ORIGINATION FORM

Proposed Revisions to a Standard Plans Index (Please provide all information — Incomplete forms will be returned)

Index Number: 455-160

Index Title: 60" Prestressed CFRP & SS Concrete Cylinder
Pile**Summary of the changes:**

INDEX
455-160

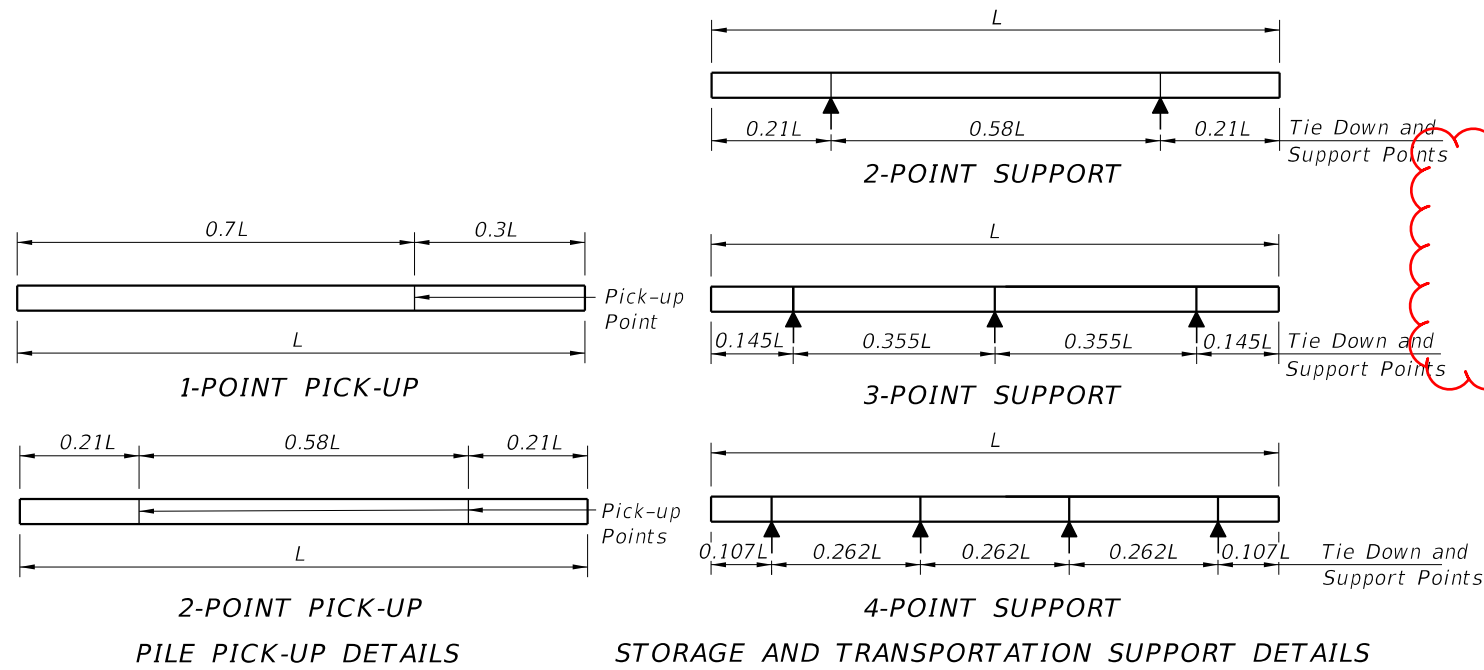
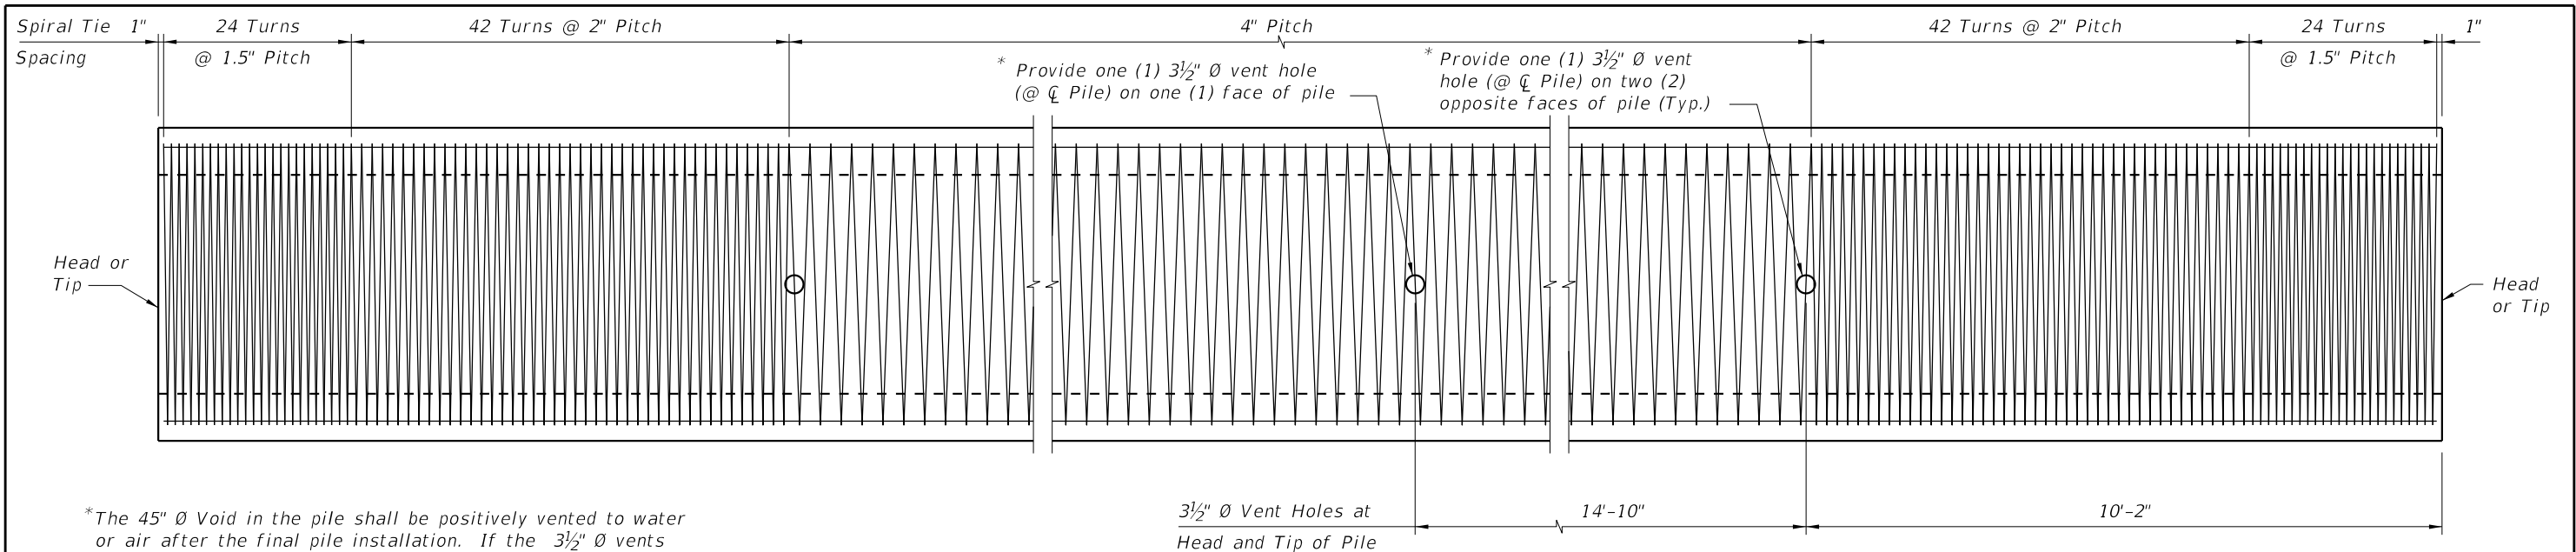
- Work this Index with the Pile Data Table in the Structures Plans.
- Concrete:
 - Piles: Class V (Special)
 - Splice Collar: Class IV
 - ~~Silica Fume: See "GENERAL NOTES" in the Structures Plans for locations where the use of silica fume, metakaolin or ultra-fine flyash is required.~~

Highly Reactive Pozzolans

Change Silica Fume, metakaolin or ultra-fine flyash to Highly Reactive Pozzolans

Specification changed to fit silica fume, metakaolin and ultra-fine flyash under Highly Reactive Pozzolans

SHEET
1 of 3

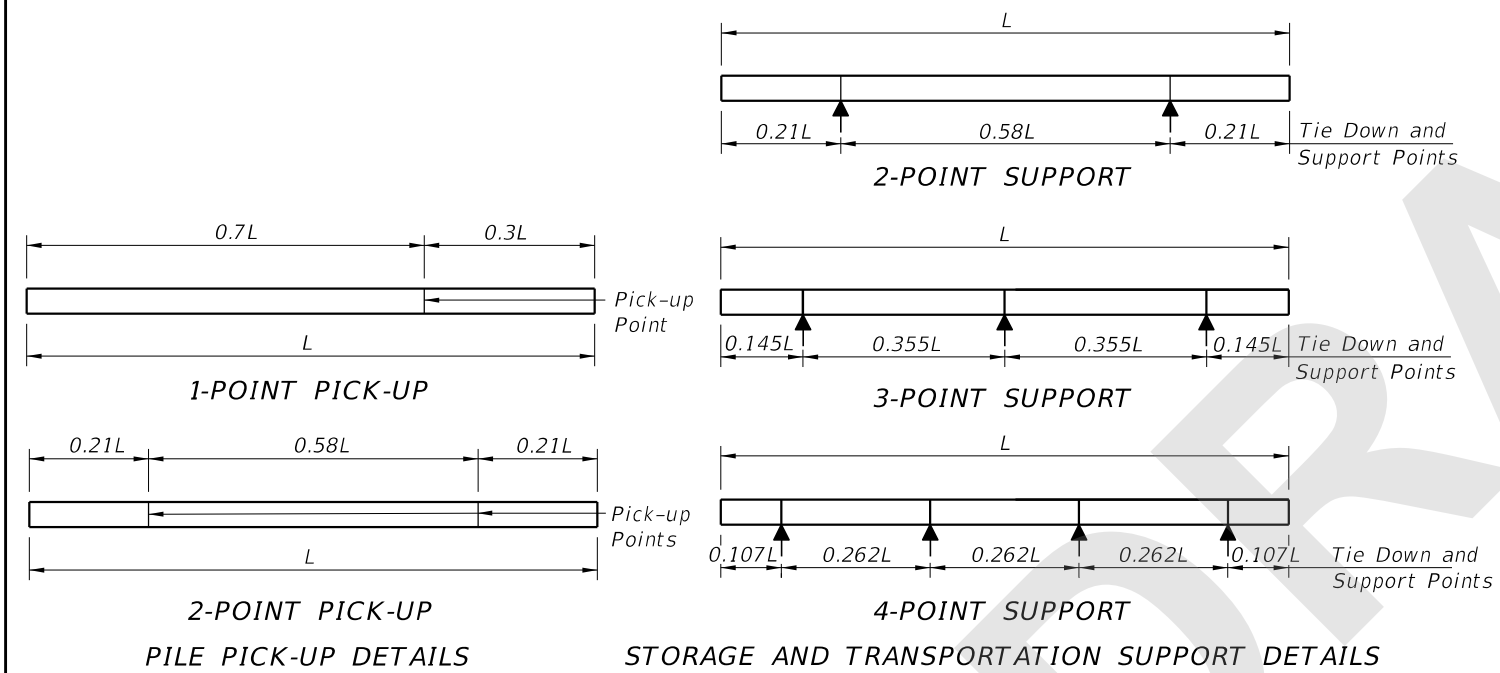
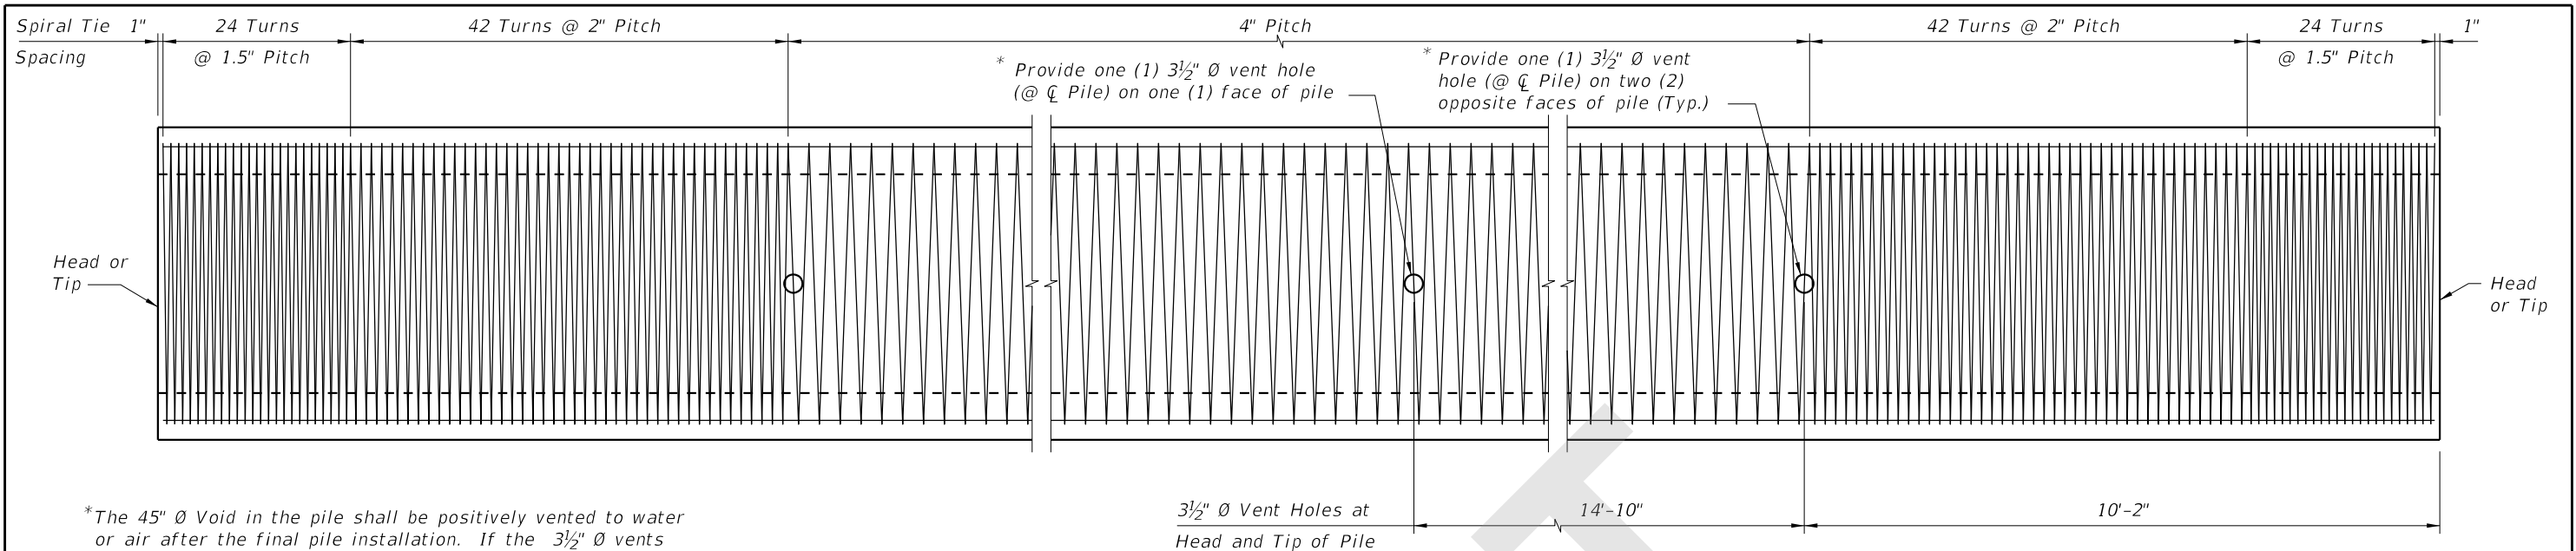
1. Work this Index with the Pile Data Table in the Structures Plans.
2. Concrete:
 - A. Piles: Class V (Special)
 - B. Splice Collar: Class IV
 - C. See "GENERAL NOTES" in the Structures Plans for locations where the use of Highly Reactive Pozzolans is required.
